EPC STORMWATER REVIEW COMMENTS
IN ORANGE BOXES WITH BLACK TEXT

Grandview Reserve Fil. No. 1

Drainage Memo

PUDSP-21-10

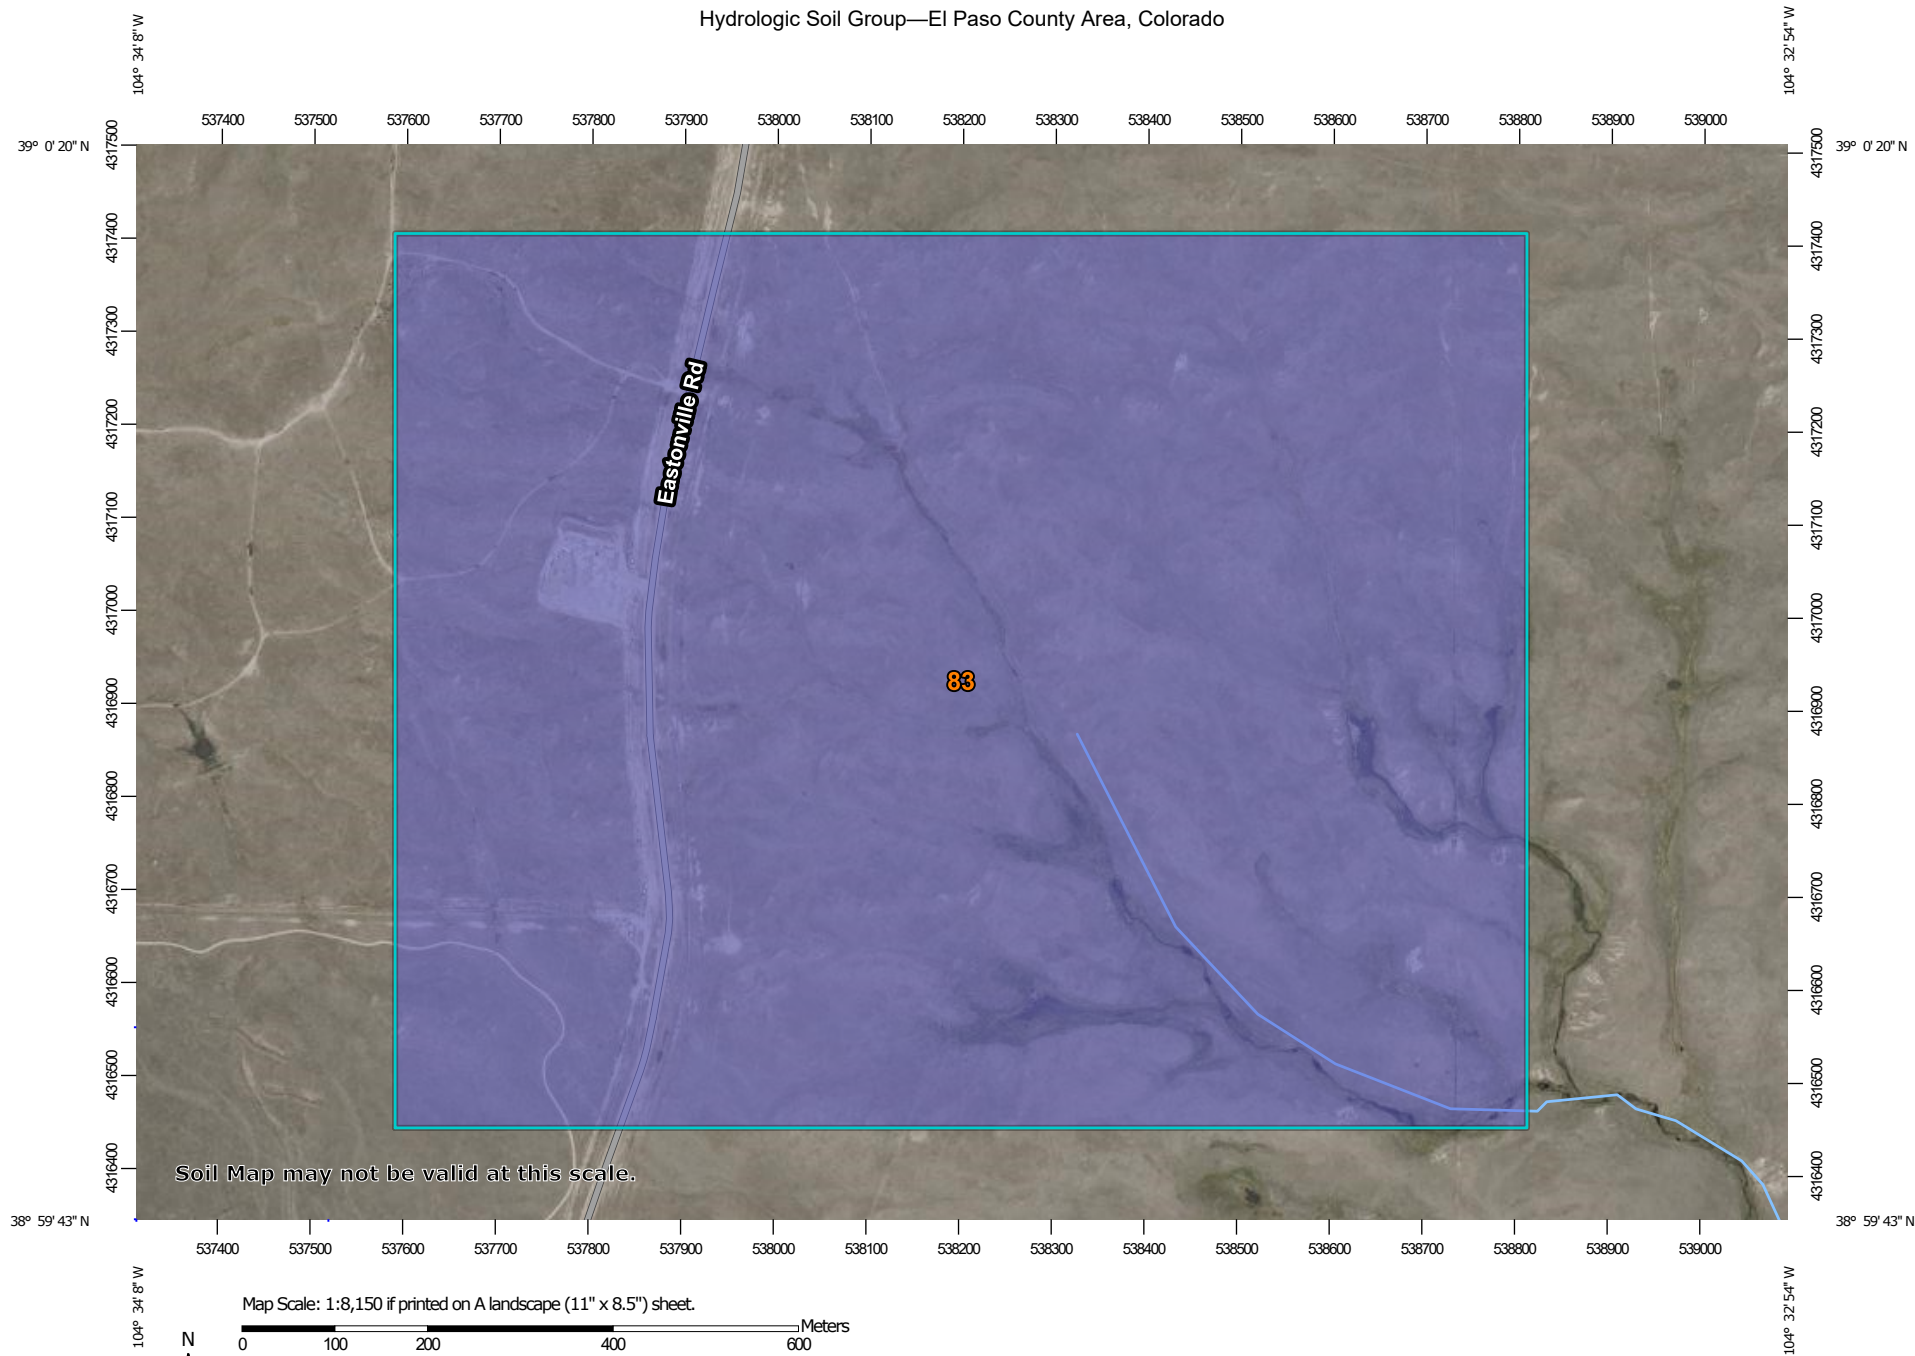
typo

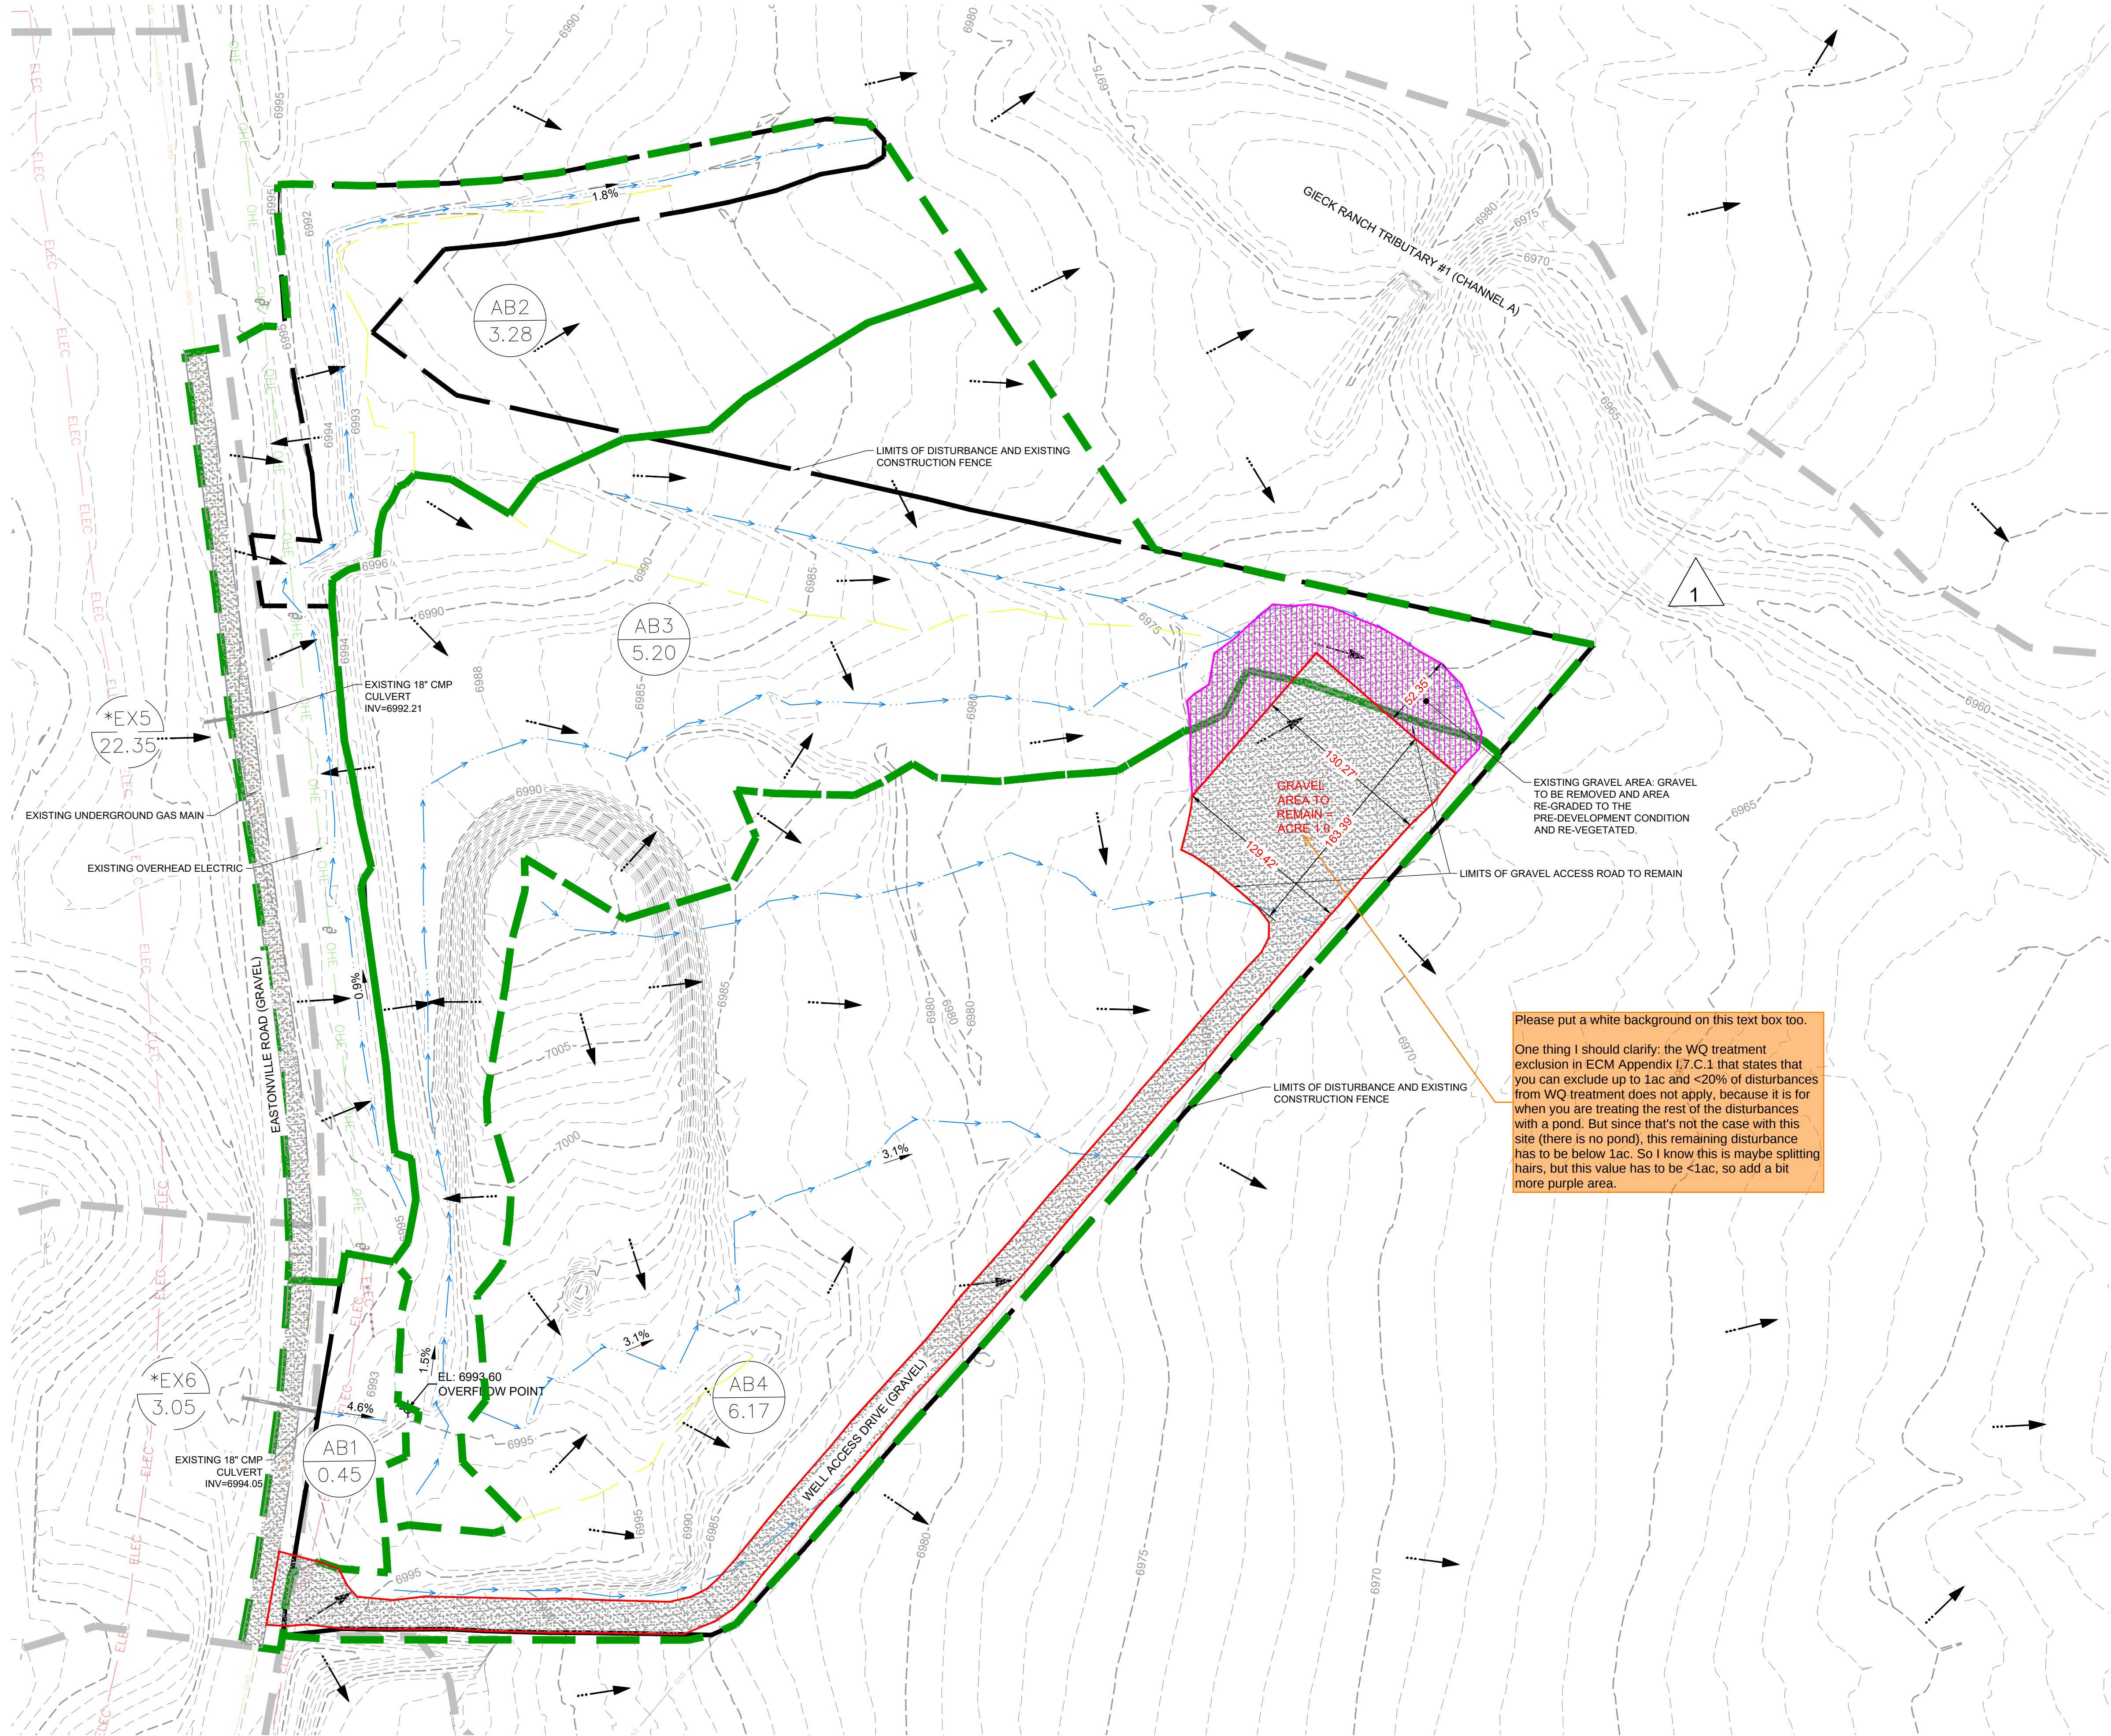
Please put a white background on this text box too.

One thing I should clarify: the WQ treatment exclusion in ECM Appendix I.7.C.1 that states that you can exclude up to 1ac and <20% of disturbances from WQ treatment does not apply, because it is for when you are treating the rest of the disturbances with a pond. But since that's not the case with this site (there is no pond), this remaining disturbance has to be below 1ac. So I know this is maybe splitting hairs, but this value has to be <1ac, so add a bit more purple area.
